MAL302-MF、MAL401-F with float switch specification design change Notification

1. Model series
MAL302-MF, MAL401-F
2. Design change reason
In order to increase product commonality, we changed the design.
3. Change descriptions

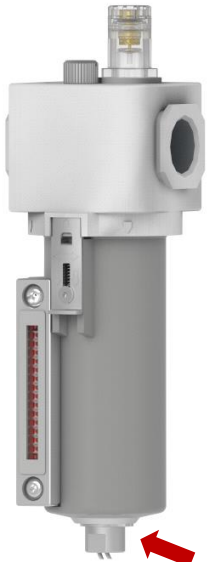
Before	After
<p>Take MAL302-MF series for example.</p>  <p>The image shows the MAL302-MF series float switch before the design change. It features a yellow float switch assembly at the bottom, indicated by a red arrow.</p>	<p>Take MAL302-MF series for example.</p>  <p>The image shows the MAL302-MF series float switch after the design change. The float switch assembly at the bottom is now grey, indicated by a red arrow.</p>
